# Access Compliance Report

## Public Rights-of-Way

### (Curb Ramps)

Intersection ID: 43227	Main Street: N I-77 EXIT 5 RA	Cross Street: N I-77 HY	Location: SW
ADA ID: 6512E9F9D8D9	Ramp Type: Perpendicular	Initial Pass/Fail: Fail	Overall Compliance: No
Codes/Mitigation Info/Possible Solution			Severity Score: 10
			Field Measurements/Component Compliance

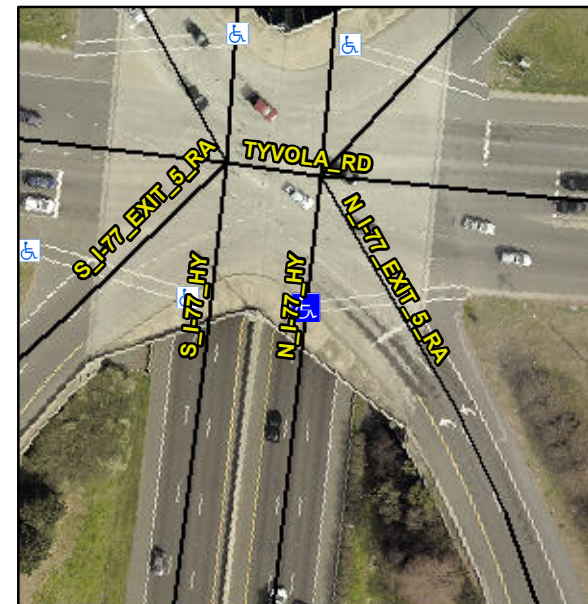
**R304.5.1, R304.5.3**

Compliance	Description	Data	Compliance	Description	Data
N/A	Ramp Length (in)	96.0	Yes	Ramp Slope (%)	6.4
No	Ramp Width (in)	40.0	No	Ramp XSlope (%)	4.3
N/A	Flare Type LT	N/A	N/A	Flare Type RT	N/A
N/A	Flare Slope LT (%)	N/A	N/A	Flare Slope RT (%)	N/A
N/A	Flare Traversable LT?	N/A	N/A	Flare Traversable RT?	N/A
N/A	Landing Length (in)	N/A	N/A	DWS Provided?	N/A
N/A	Landing Width (in)	N/A	N/A	DWS Contrast?	N/A
N/A	Landing Slope (%)	N/A	N/A	DWS Length (in)	N/A
N/A	Landing X Slope (%)	N/A	N/A	DWS Full Width?	N/A
N/A	Landing Curb? (Y/N)	N/A	N/A	DWS Offset (in)	N/A
N/A	Shared Landing?	N/A			
N/A	Gutter Ponding?	N/A	N/A	Gutter Slope (%)	N/A
N/A	Gutter Lip Ht (in)	N/A	N/A	Gutter X Slope (%)	N/A
N/A	Painted X Walk1?	Yes	N/A	Painted X Walk2?	N/A
	X Walk 1 Direction	To E		X Walk 2 Direction	N/A
N/A	X Walk 1 Width (in)	55.0	N/A	X Walk 2 Width (in)	N/A
	X Walk 1 Slope (%)	0.9		X Walk 2 Slope (%)	N/A
	X Walk 1 X Slope (%)	2.7		X Walk 2 X Slope (%)	N/A

**Remove & Replace Entire Ramp.**
